**WHEELING PLAN COMMISSION
THURSDAY, JULY 28, 2016 6:30 P.M.**

REQUEST FOR PLAN COMMISSION ACTION
STAFF PROJECT REVIEW

RE: **Docket No. 2016-16**
OMNI Youth Services
210-212 N. Wolf Road
Special Use-Site Plan Approval for a Social Service Facility

RE: Docket No. 2016-17
Blooming Minds Academy
581-583 N. Wolf Road
Special Use-Site Plan Approval of a Daycare Center

PROPOSED PHASING FLOOR PLAN

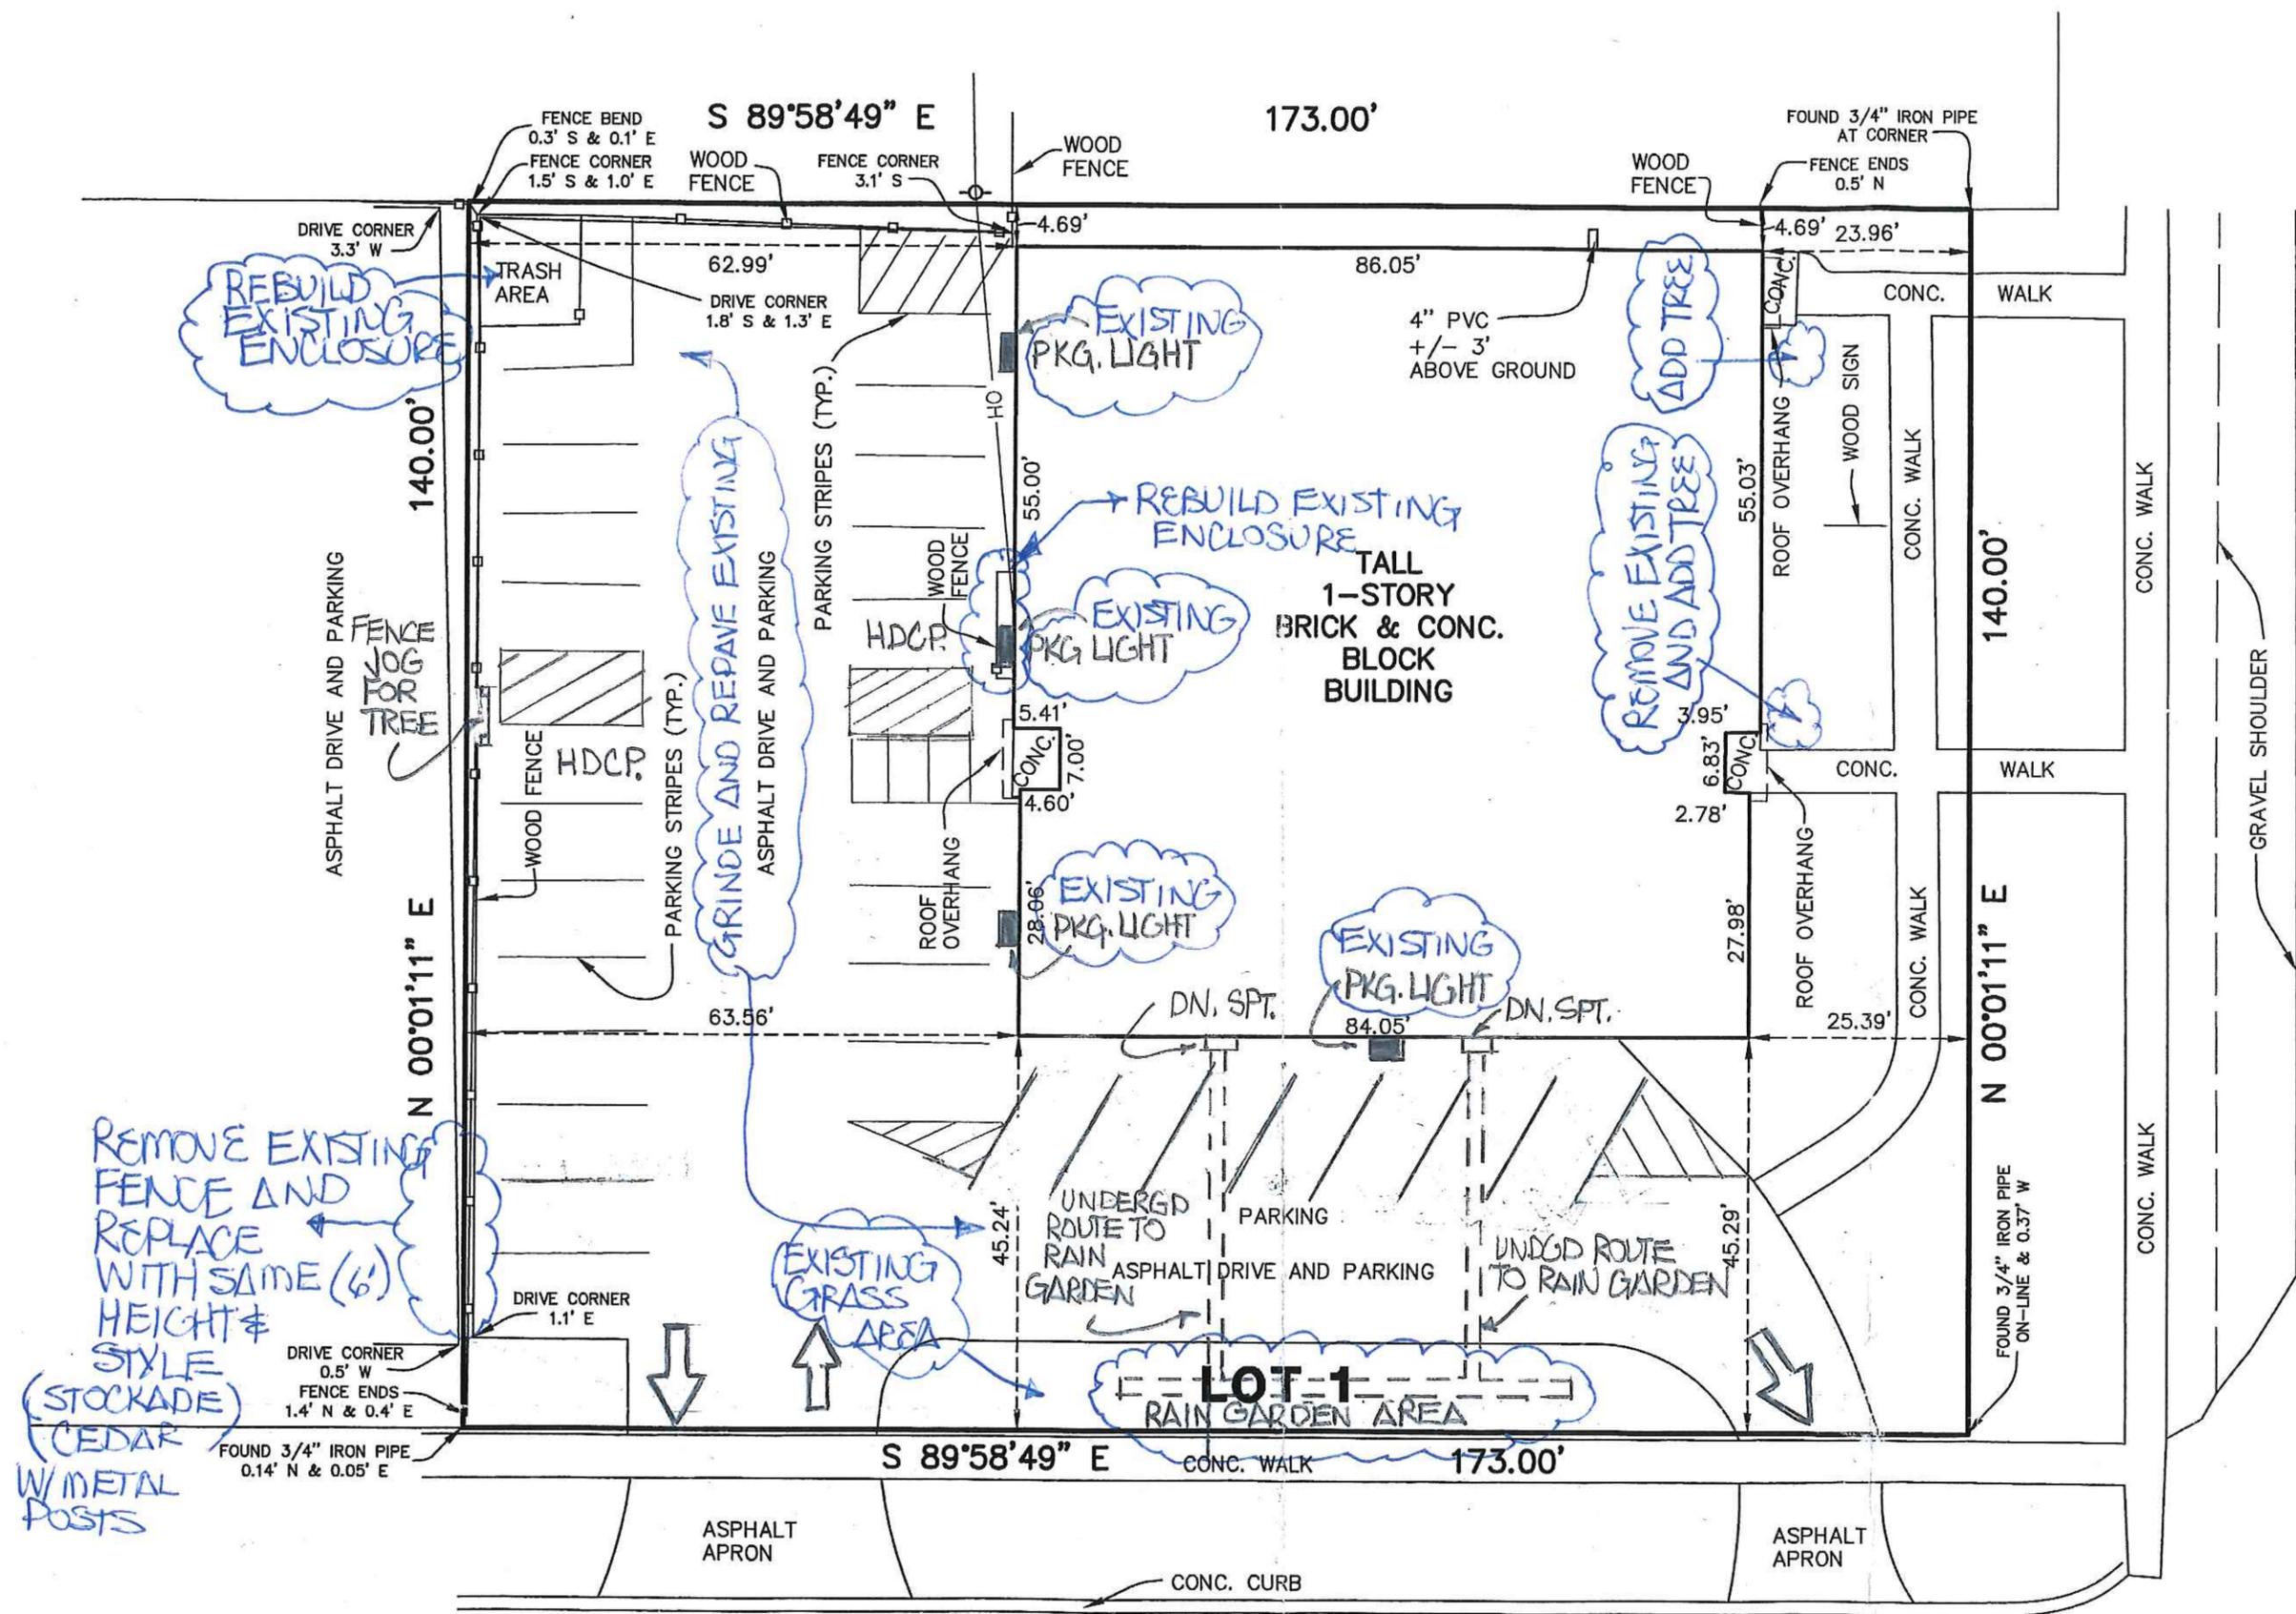
Fire Department Review: The Fire Department has reviewed the plans and provided a comment memo, dated July 19, 2016. Based on the information provided on the floor plan dated June 14, 2016 (received June 23, 2016), the improvements to the interior are to be completed in three phases. The program for the space in the full three-phase buildout appears to represent an increase in the occupant load as compared to the previous use. As noted in the Fire Department memo, an increase in the occupant load would require the installation of a Fire Suppression system. See additional notes under Staff Recommended Action.

ADDITIONALLY, the Plan Commission may wish to seek additional details from the petitioner regarding the schedule for the phased buildout, as well as details for the function of the group rooms, meeting rooms, and large group room. The conditions of approval relating to the length of time for initiating the special use and the occupant load of the unit may need to be adjusted following the discussion.

- a. The building would be required to be retrofitted with an automatic fire sprinkler system. Although there is no change in the buildings Use Group, the revisions to the building provide for the addition of seven large rooms to be used as meeting rooms and/or large group rooms. Based on a variety of options for utilization of these rooms, these changes would all lead to varying increases in the building's design occupancy load. Under Section 1103.5.3 of the Village's Fire Prevention Code, an automatic sprinkler system is required in existing buildings in Use Groups A, B, E, F, H, I, M, R, and S when the hazard category or occupancy load is increased.

1. The improvements of the space as shown on the floor plan submitted June 23, 2016 may be completed in multiple phases, with the expectation that the full buildout will be complete within X years of special use approval;
2. The unit shall be retrofitted with an automatic fire sprinkler system at such time as required by the Code, and subject to a review of the occupant load associated with the building permits for each phase of the improvements to the unit.

A-1

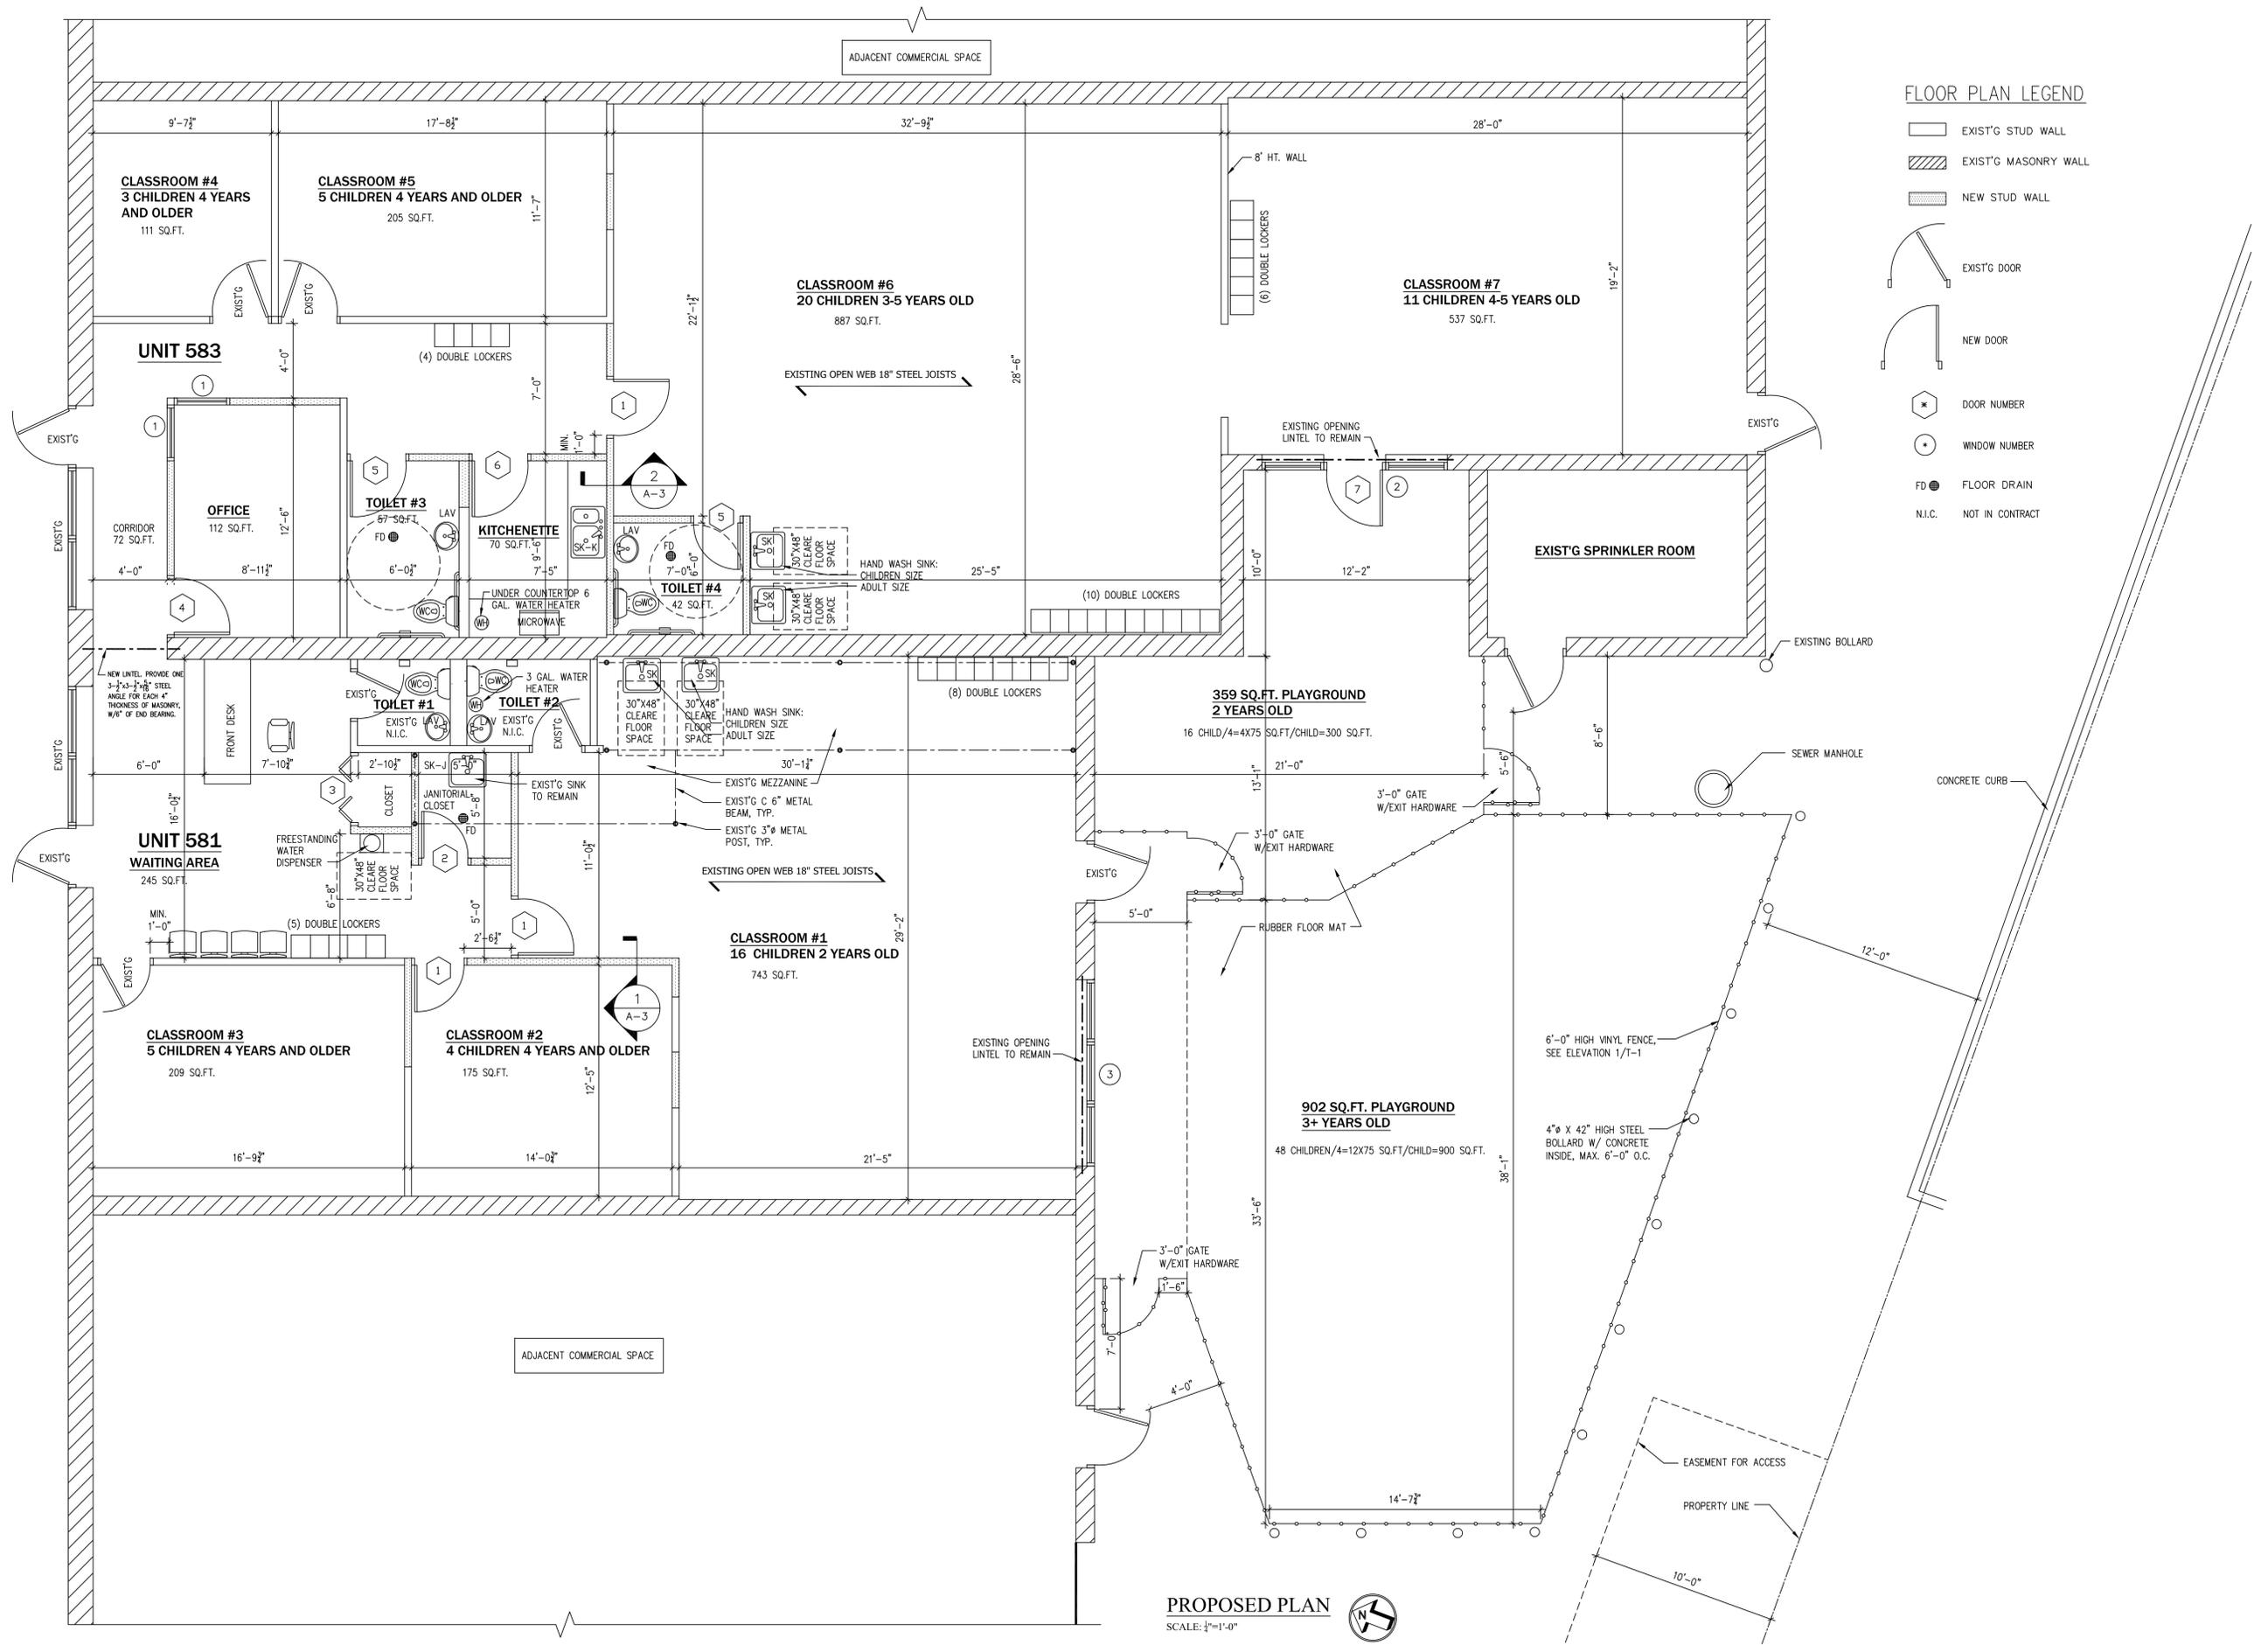
Floor Plan: The petitioner is proposing to expand from the current location at 581 into the adjacent unit 583. Both units will be reconfigured to accommodate the changing use and additional daycare facilities. There will be a total of 7 classrooms, an office, a waiting area, a kitchenette, and toilets.

A-2

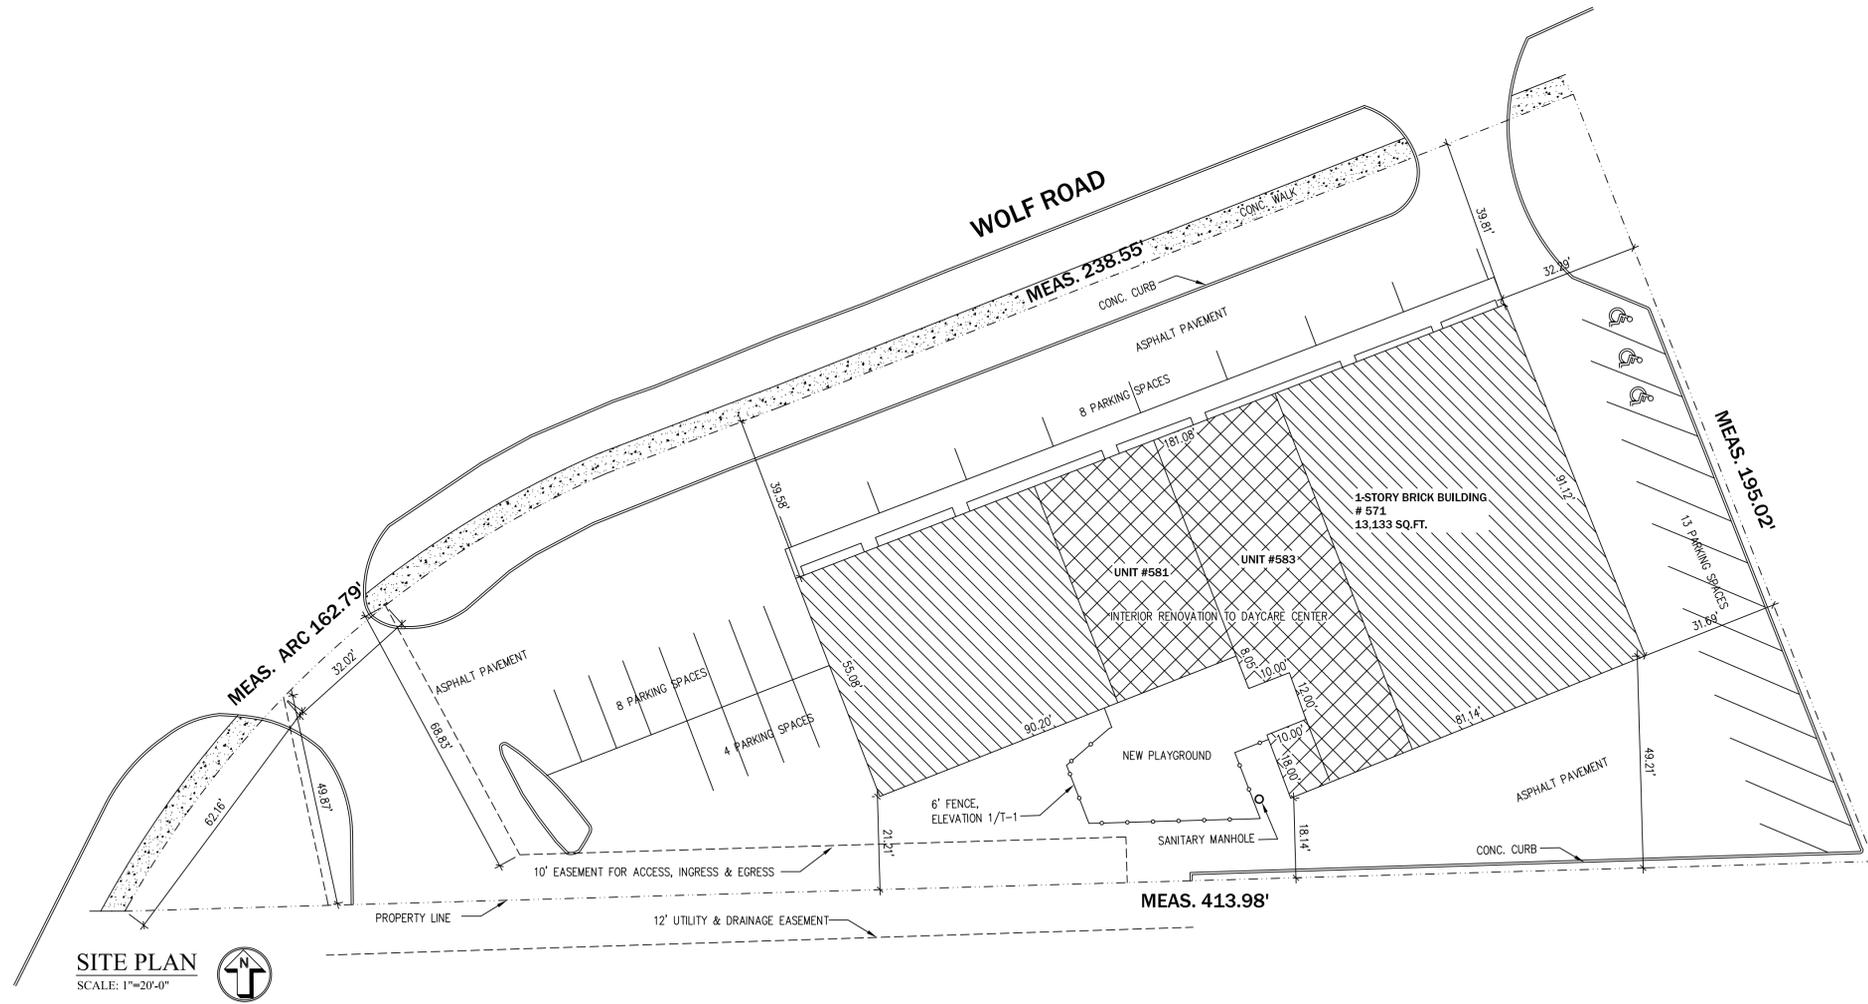
1. The petitioner is proposing to expand their existing business at 581 N. Wolf Road into an adjacent tenant space at 583 N. Wolf Road. They would then remodel and occupy both tenant spaces as one tenant space. There would be a change in Use Group from the existing mixed use (B) Business Use Group and (F) Factory or (S) Storage occupancy as defined in the 2012 Edition of the International Building (IBC) and Fire Prevention Codes (IFC) to an (E) Educational Use Group occupancy for the proposed occupancy.
